June 17, 2026**Addendum No. 02****File Reference Number: RFP 2026 031****Title: Cochrane Station Parking Lot Paving Project****RE: Clarifications/Questions**

APPENDIX H - ISSUE FOR TENDER DRAWINGS (ADDENDUM NO. 02)

Please refer to the below drawing CSK12-202 of the RFP which shows the full East platform and the required slopes.

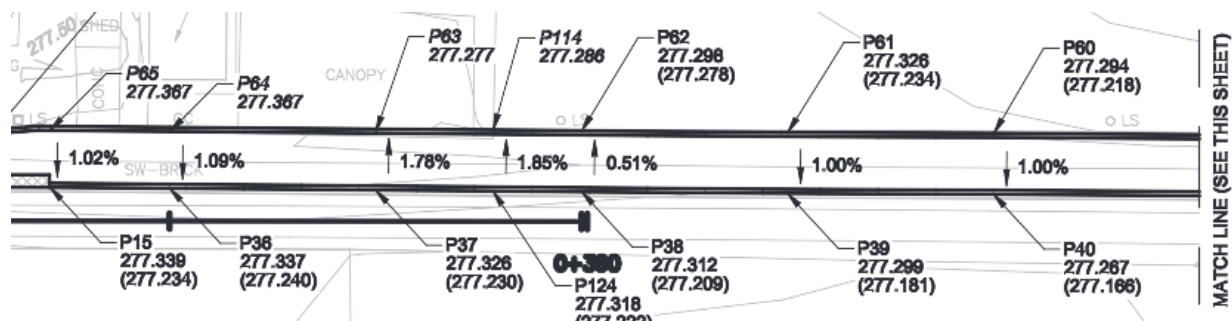
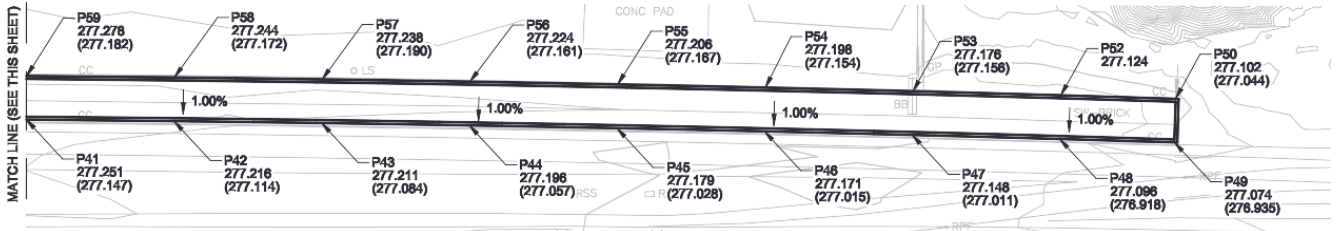
Item 6: Please confirm if there is any new concrete platform to be constructed.

The East interlocking brick platform will be re-leveled and NEW brick installed. If you refer to Plan 25-1298 Drawing 7, it shows the area of the platform that will require the removal of the existing interlock bricks, re-leveling and the supply and installation of NEW interlock bricks. There will be NEW curbs required on each side and end of the platform.

A painted yellow line 24" wide for the full length of the platform will be required to match the tactile that is already installed on the existing platform on track side. Drawings CSK12-201, CSK12-202, CSK-202A give you the grading information for the east platform work.

Answer: There is no concrete platform to construct.

This addendum also shows the additional interlock and curb work that is required.

a) Additional Platform Curbs and Interlock Work

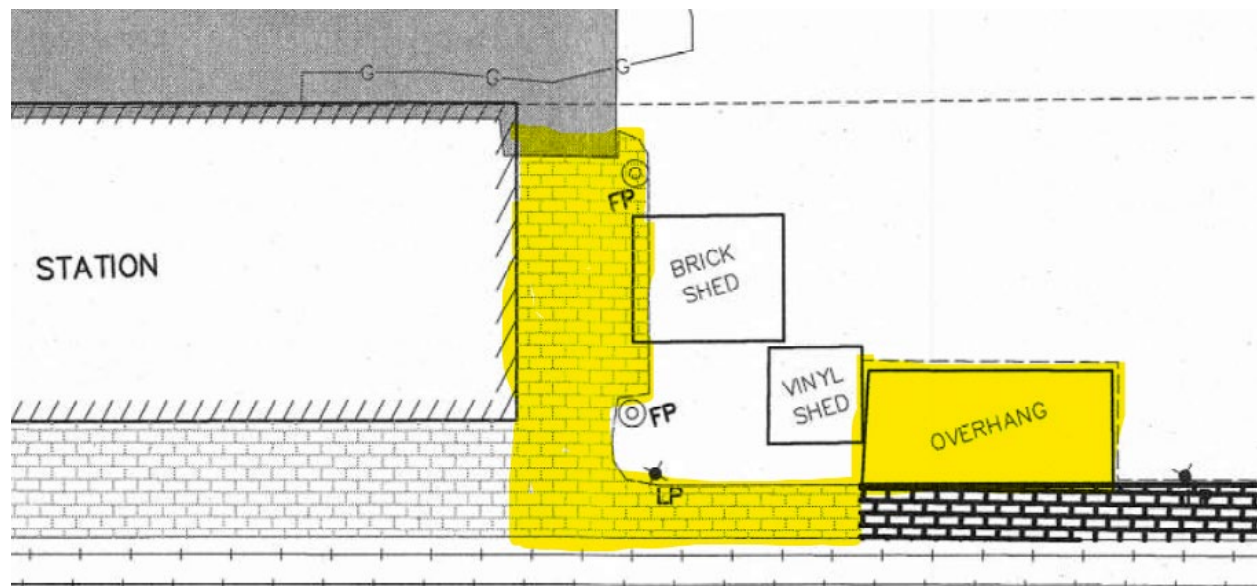
Please be advised that the below items have been added to the Scope of Work outlined in the above referenced section.

There are two (2) areas that are added to the platform work. These areas are shown below.

- Interlocking Concrete Pavers work area: 290 m²
- Refer to revised Appendix D – Schedule of Prices (Addendum No. 02) for quantities and quoting breakdown.

DRAWING TITLE: REMOVALS LAYOUT

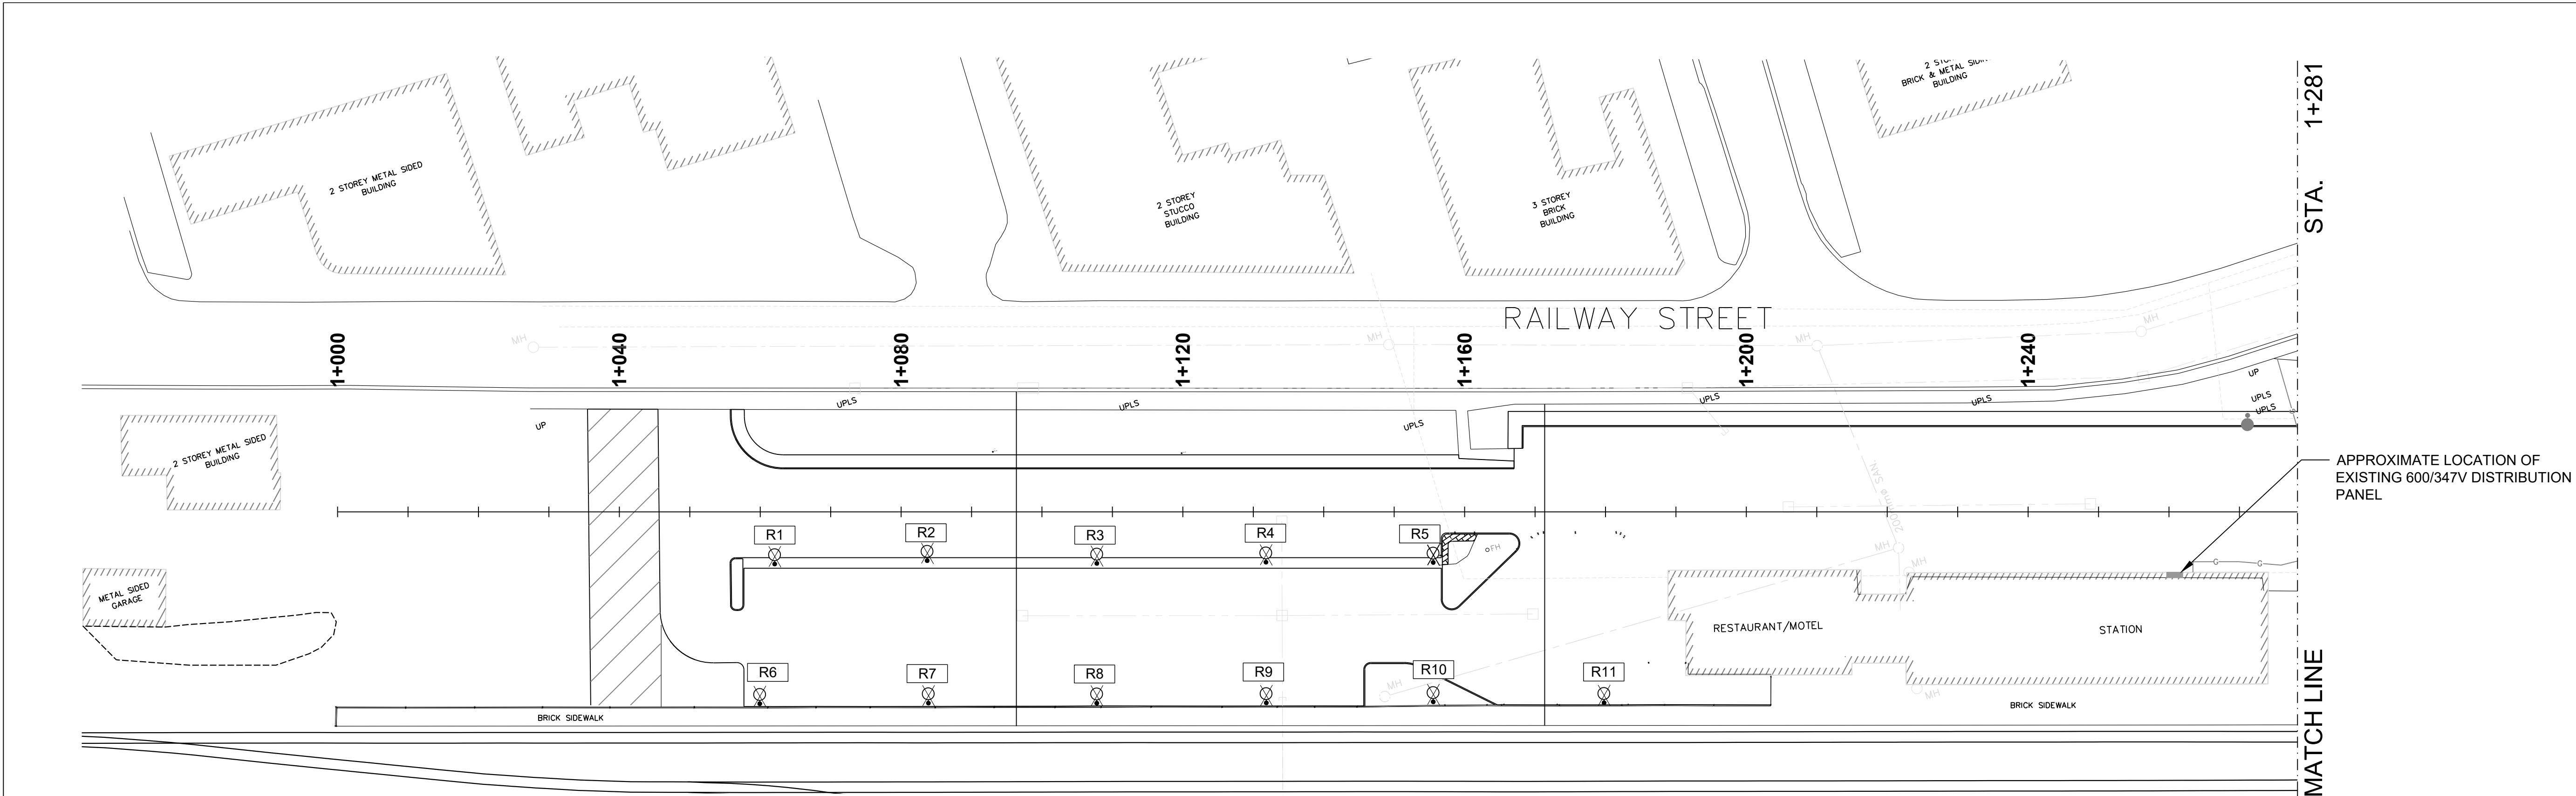
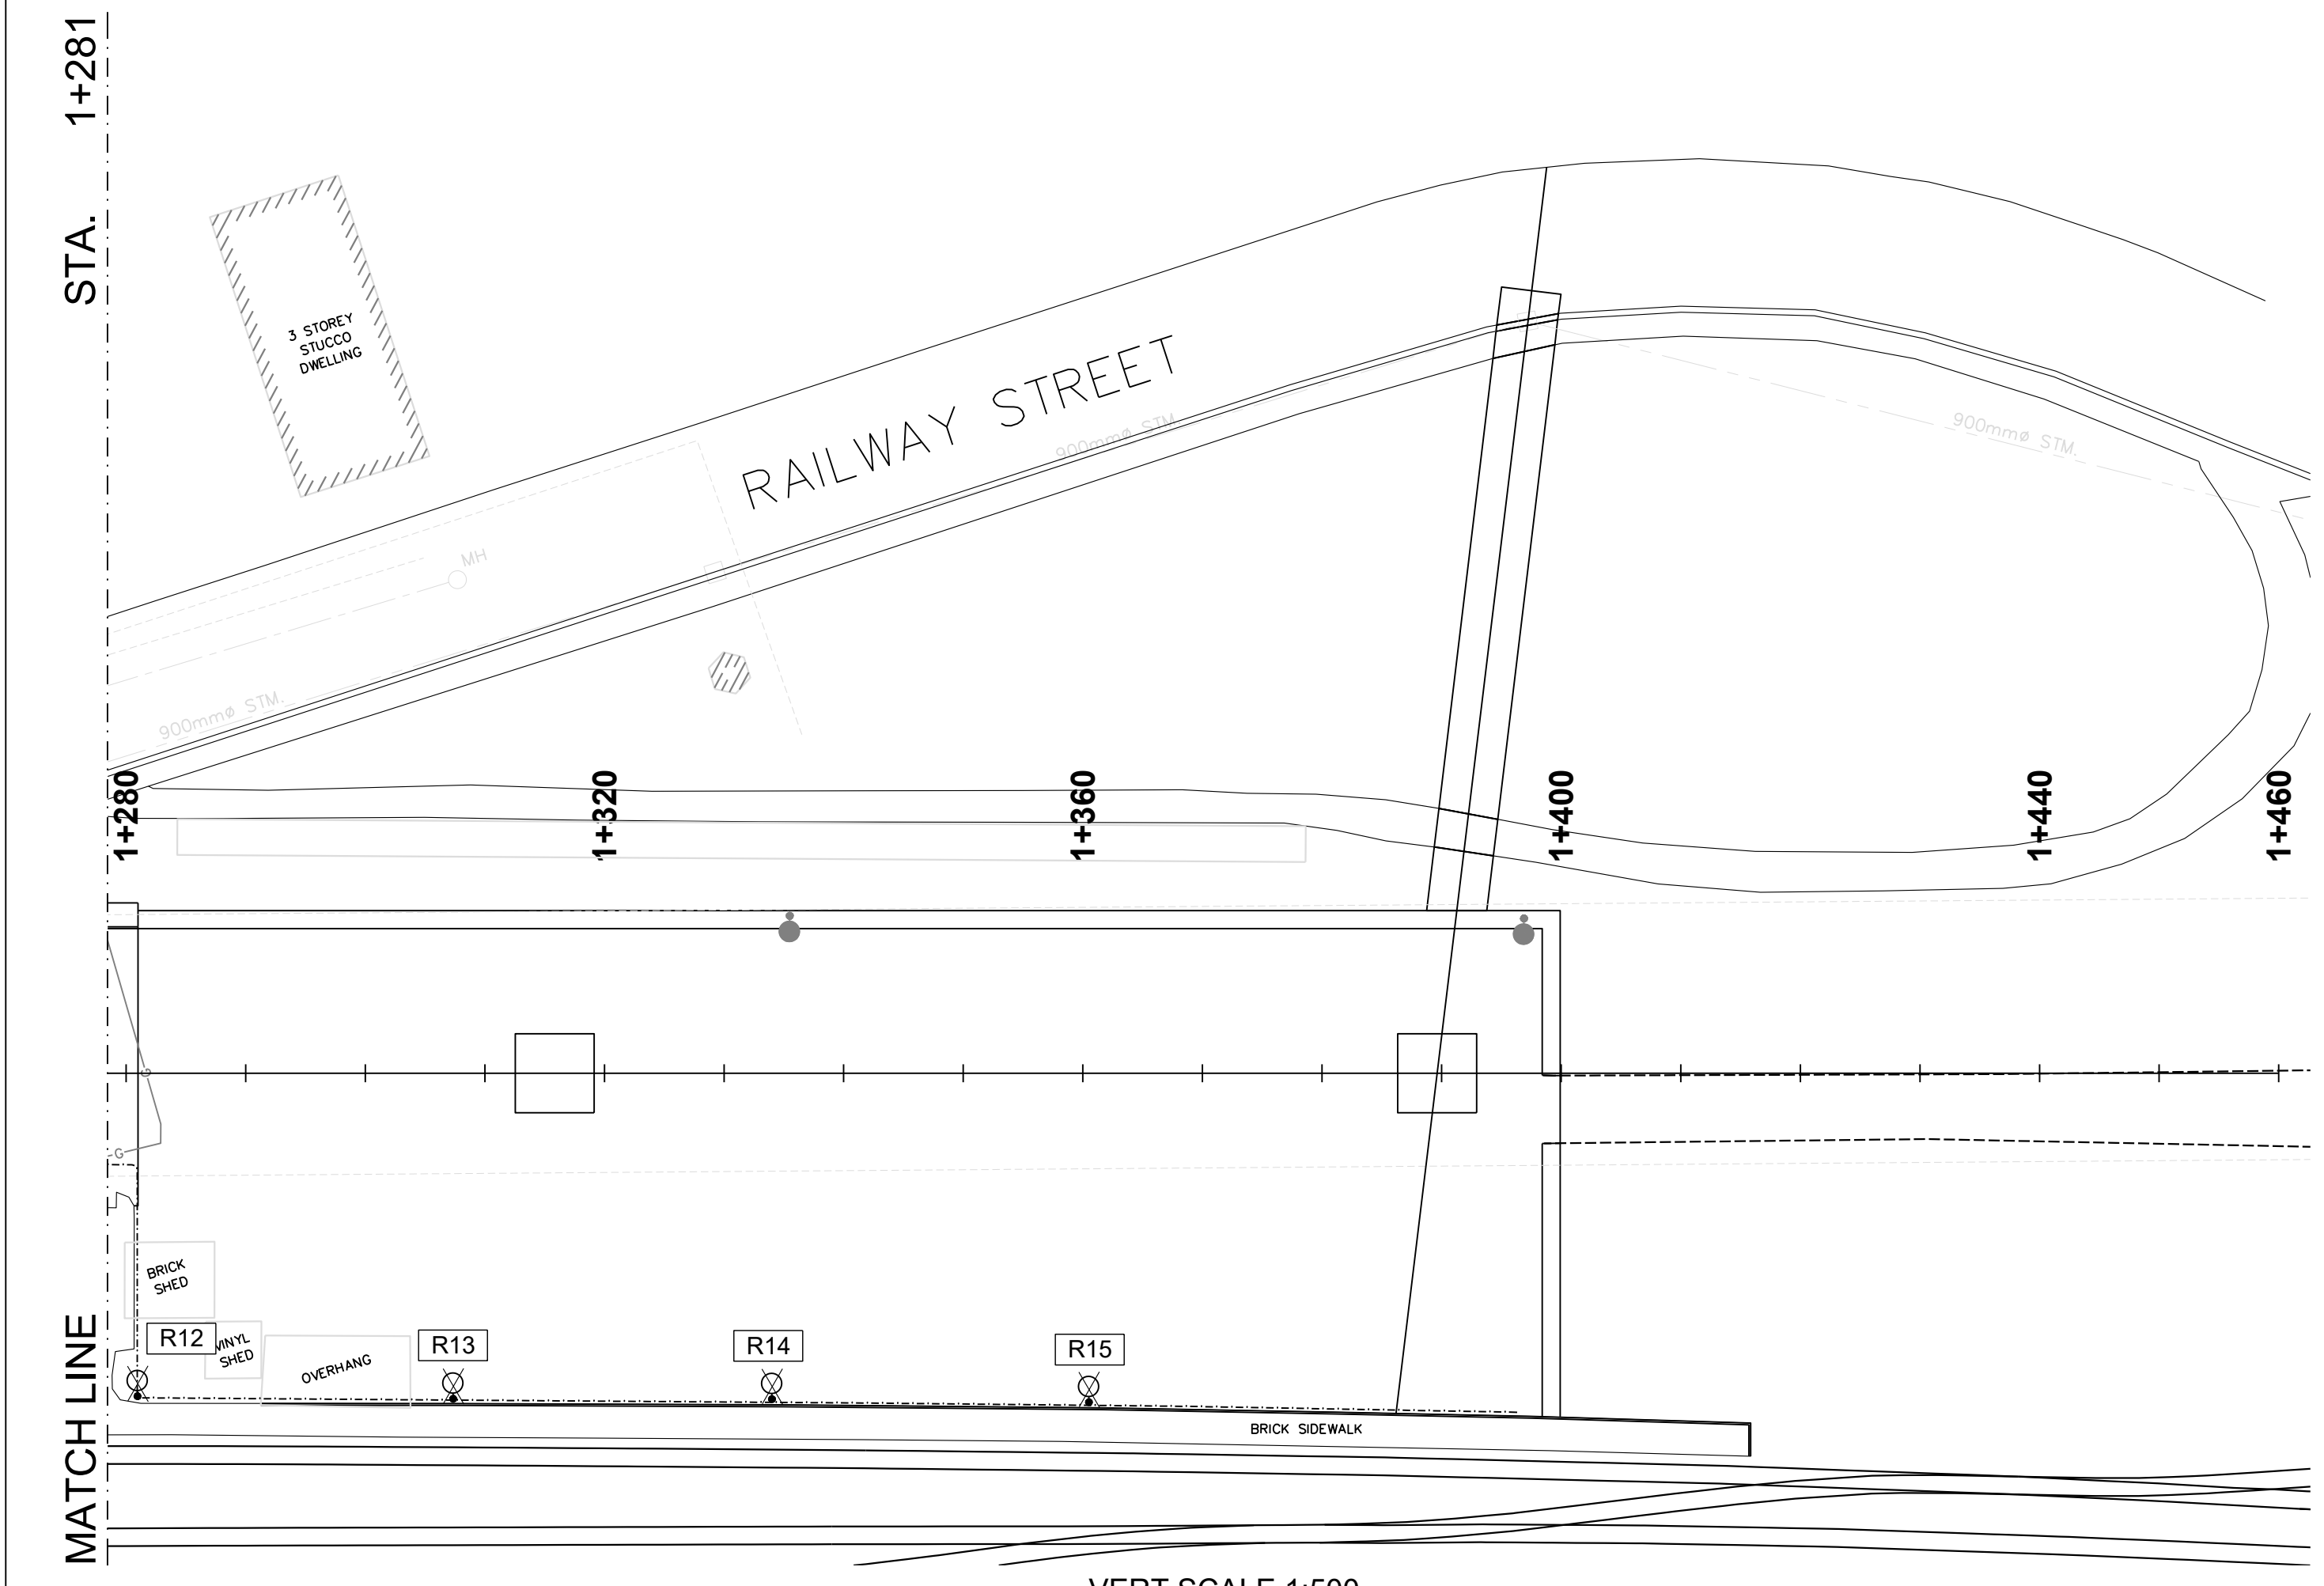
- Drawing E-101 has 15 each remove existing luminaires
- Item 45 on the schedule of prices has a quantity of 16 each

Answer: 15 poles are to be removed. Item 45 should read 15. Appendix D – Schedule of Prices has been updated to reflect this and has been provided as a separate attachment to this Addendum No. 02

Answer: Please be advised that the scales shown on the drawings are correct. However, when the drawings were stamped and scanned to PDF, a slight reduction in size occurred. The PDF has since been adjusted to restore the drawings to the correct scale.
